June-07-12 9:17:35 AM D412-664-203 Item ID: Revision ID: Item Name: Crosstube Aft Start Oty: 1.00 **Start Date:** 07/06/2012 **Required Date:** 21/06/2012 **Req'd Qty:** 1.00 Reference: Approvals:

DART AEROSPACE LTD	Work Order:	<i>8</i> 5368
Description: Crosstube High Aft (412)	Part Number:	D412-664-203
Inspection Dwg: D412-664-243 Rev: E		Page 1 of 1

DRAWING NO.	TITLE	REV. E	DART AEROSPACE LTD	D.E.O. NO.	SHEET NO.	SCALE
D412-664-243	CROSSTUBE ASSEM	BLY (412 HI AFT)	ENGINEERING ORDER	D412-664-243-E-1	SHEET 1 OF 2	NTS
DRAWN	CHECKED	M	MFG. APPR.	APPROVED MAP	DE APPR.	
DATE 11.03	.31 DATE	11/03.31	DATE //.03.31	DATE 11/03:3)	DATE 11-03.31

DRAWING NO.	TITLE	REV. E	DART AEROSPACE LTD	D.E.O. NO.	SHEET NO.	SCALE
D412-664-243	CROSSTUBE ASS'Y	412 HI AFT)	ENGINEERING ORDER	D412-664-243-E-2	SHEET 1 OF 1	NTS
DRAWN 9	CHECKED	ASS	MFG. APPR.	APPROVED M	DE APPR.	
DATE 11.09	0.07 DATE	11.09.19	DATE ((.09.19	DATE 11.09.19	DATE 11.09.19

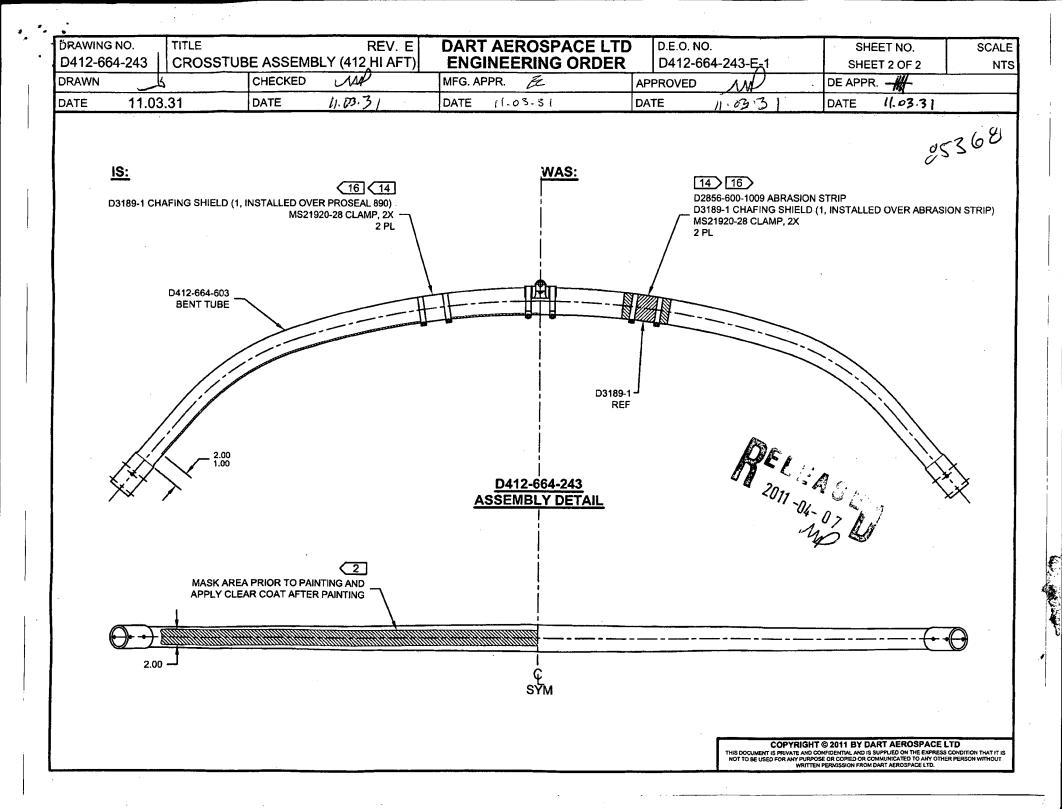
PURPOSE:

REMOVED ABRASION STRIP IN FAVOR OF A THIN LAYER OF PROSEAL 890.

PARTS LIST IS AMENDED AS FOLLOWS:

Item	Qty -243	Part Number	Description
6	0	D2856-600-1009	ABRASION STRIP

6	2	D2856-600-1009	ABRASION STRIP

NOTES 2 AND 14, SHEET 1 ARE AMENDED AS FOLLOWS:

2) FINISH: CHEMICAL CONVERSION COAT PER DART QSI 005 4.1
PRIME INSIDE AND OUTSIDE PER DART QSI 005 4.2
PAINT OUTSIDE PER DART QSI 005 4.2

14) INSTALL D2856-600-1009 ABRASION STRIPS WITH A 0.13 REF GAP ON BOTTOM SIDE OF CROSSTUBE PER QSI 035.

2) FINISH: CHEMICAL CONVERSION COAT PER DART QSI 005 4.1
PRIME INSIDE AND OUTSIDE PER DART QSI 005 4.2

MASK UNDERSIDE OF CROSSTUBE AS SHOWN (HATCHED AREA)

PAINT OUTSIDE PER DART QSI 005 4.2

AFTER PAINTING, APPLY CLEAR COAT ON HATCHED AREA

14) APPLY A THIN COAT OF PROSEAL 890 ON INSIDE CONCAVE SURFACE OF D3189-1 CHAFING SHIELD AND LET CURE PER MANUFACTURER'S INSTRUCTIONS. INSTALL PROSEALED D3189-1 CHAFING SHIELD ONTO CROSSTUBE BY APPLYING A THIN COAT OF PROSEAL 890 ONTO CROSSTUBE. BE SURE TO ELIMINATE ANY AIR GAPS.
